## **TRAIL RIDGE**

## **LANDFILL**

**PLAN A**

SUBJECT: Trail Ridge Landfill - Plan A

FIG. 8.27. Positioning of gas extraction well for complete overlap (a) triangular array, (b) hexagonal array. Solid circles indicate locations of gas extraction wells.

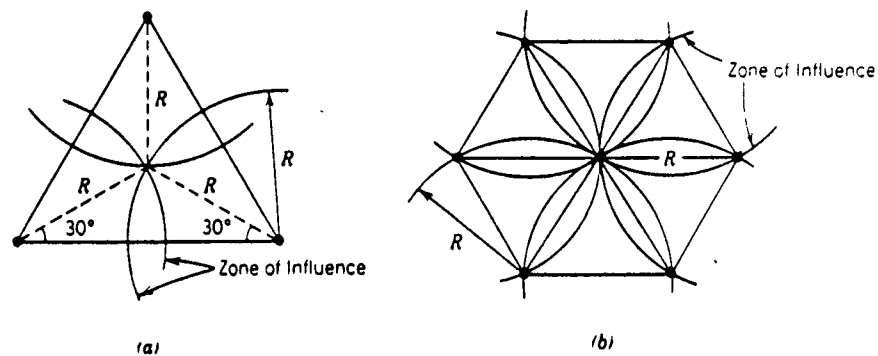
QUESTION 3: Please justify using a 300-foot zone of influence for gas vents instead of the 300-foot centers that the Department normally requires.

RESPONSE 3: A 300-foot hexagonal array provides a 100% overlap versus a 60% overlap for 300-foot centers. (see attachment)
